HISTORIC AND DESIGN REVIEW COMMISSION

HDRC CASE NO: 2022-142
COMMON NAME: Fredericksburg Rd (Mary Louise to W Rosewood)
LEGAL DESCRIPTION: NCB 6700 BLK 9 LOT 13, 14 & E 15 FT OF 12
ZONING: UZROW, H
CITY COUNCIL DIST.: 7
DISTRICT: Monticello Park Historic District
APPLICANT: Miranda Garrison/City of San Antonio
OWNER: City of San Antonio
TYPE OF WORK: ROW improvements
APPLICATION RECEIVED: February 22, 2022
60-DAY REVIEW: Not applicable due to City Council Emergency Orders
CASE MANAGER: Rachel Rettaliata

The applicant is requesting a Certificate of Appropriateness for approval to install new sidewalks and curbing along the west side of Fredericksburg Road from Mary Louise to W Rosewood.

**SUBJECT: Request for Certificate of Appropriateness
D7 Pedestrian Improvements – Fredericksburg Rd. (Mary Louise Dr. to W.
Rosewood Ave.)
San Antonio, Bexar County, Texas**

CITY OF SAN ANTONIO
Transportation & Capital Improvements (TCI) Department
FREDERICKSBURG RD SIDEWALK IMPROVEMENTS
PROPOSED SIDEWALK IMPROVEMENTS

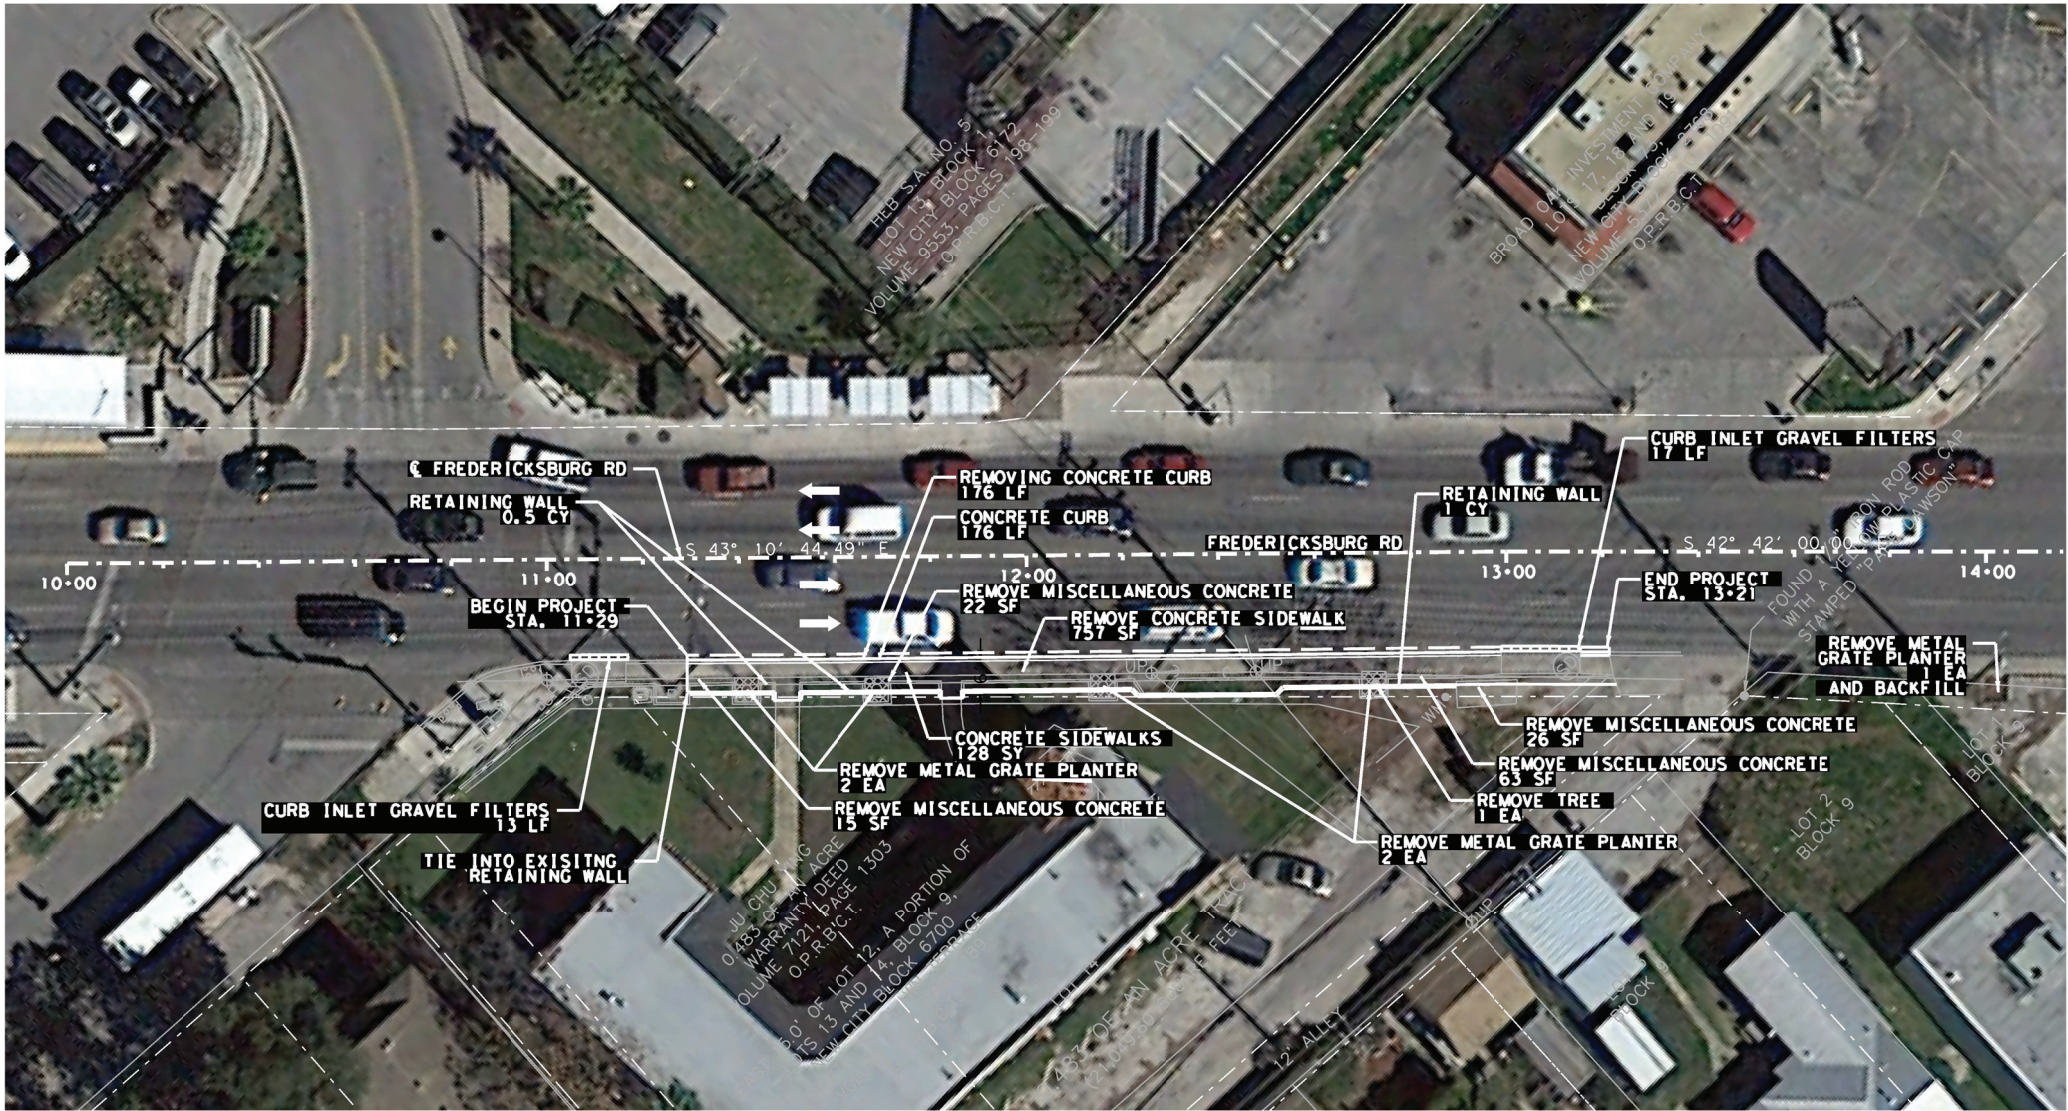
- b. **SIDEWALK INSTALLATION** – The applicant has proposed to install 6-foot-wide sidewalks and curbing on the west side of Fredericksburg Road between Mary Louise and W Rosewood. Guideline 5.A.iii for Site Elements states that the installation of new sidewalks should follow the historic alignment, configuration, and width of sidewalks and walkways. Alter the historic width or alignment only where absolutely necessary to accommodate the preservation of a significant tree. Additionally, Guideline 5.C.i for Site Elements states that historic curbing should be retained wherever possible. Historic curbing in San Antonio is typically constructed of concrete with a curved or angular profile. Staff finds the proposal generally appropriate, and that the applicant should provide dimensions for the proposed sidewalks.

- c. **TREE WELL REMOVAL** – The applicant has proposed to remove one tree and tree well located to the east of the property at 2031 Fredericksburg. Guideline 3.D.i for Site Elements states that existing mature trees and heritage trees should be preserved and protected from damage. Staff finds the proposal appropriate.

Staff recommends approval of the proposed sidewalk improvements based on findings a through e with the following stipulations:

- i. That the historic curbing is retained and any curbing that requires replacement matches the existing in material, width, and profile.
- ii. ARCHAEOLOGY – The project shall comply with all federal, state, and local laws, rules, and regulations regarding archaeology, as applicable.
